IDAP REPORT

Property:	18 Francis Street Strathfield Lot: 1 DP: 1056189 DA2021.312
Proposal:	Demolition of existing building, construction of a two (2) storey dwelling house with attached carport, front fencing and associated landscaping works.
Applicant:	CN Tanga
Owner:	Christopher Tang
Date of lodgement:	1 December 2021
Notification period:	6 December 2021 - 19 December 2021
Submissions received:	Nil
Assessment officer:	L Gibson
Estimated cost of works:	\$570,000.00
Zoning:	R2-Low Density Residential - SLEP 2012
Heritage:	No - adjoins a Heritage Listed Item (I182) and Merley Rd Heritage Conservation Area under Schedule 5 of the <i>SLEP, 2012</i> .
Flood affected:	Yes
Is a Clause 4.6 Variation Proposed:	No
RECOMMENDATION OF OFFICER:	APPROVAL

Figure 12: Proposed Concept Landscape Plan

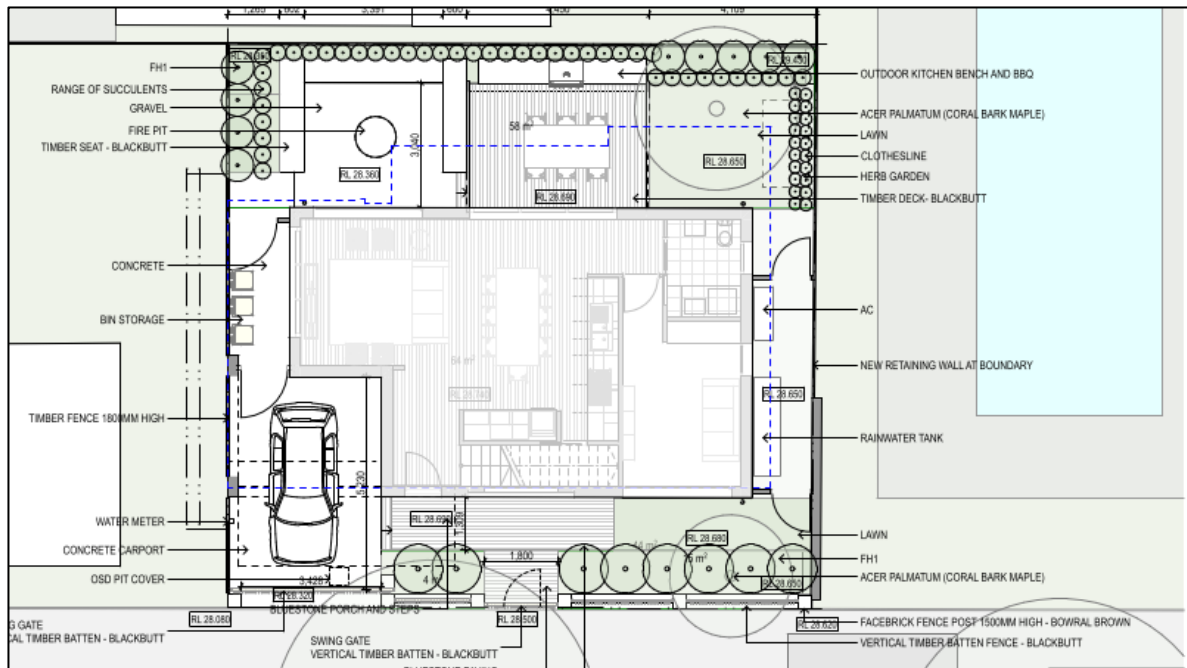
The proposal was accompanied by a schematic landscape plan which seeks to embellish the site with new tree canopy tree plantings both in the front and rear setbacks of the site, new low-lying shrubbery around the peripheries of the site and a consolidated parcel of deep soil zone each in the front and rear setbacks of the site (refer to Figure 12 below).

Whilst the proposed concept appears generally acceptable, there is scope to provide additional deep soil zone in the front setback of the site through reduction in the width and length of the front porch decking area. A condition of consent is therefore recommended requiring (at minimum) 2.7m² of the front decking area to be removed and replaced with deep soil zone. This should assist in further reducing the appearance of hardstand surfaces in the front setback and maximise opportunities for planting where possible.

Overall, subject to conditions, the proposal whilst not numerically compliant in deep soil zone, generally achieves the objectives of the controls through provision of landscaping that is suitable to the design and scale of the development.

Amendments made in red on approved plans	All changes made in red on the approved plans shall be updated and shown on the Construction Certificate plans.
Deletion of front decking area	A minimum 2.7m ² of the front decking area must be removed/deleted and reinstated with deep soil zone so to provide more meaningful consolidated parcels of deep soil area and further soften the built form.

- (d) Details of planting procedure and maintenance;
- (e) Landscape specification;
- (f) Details of drainage and watering systems;
- (g) Details of garden edging and turf;
- (h) Additional deep soil zone required as a result of the reduced 2.7m² front decking area and driveway width; and
- (i) Any required fencing, retaining walls and other structures not shown on other approved architectural and engineering plans.
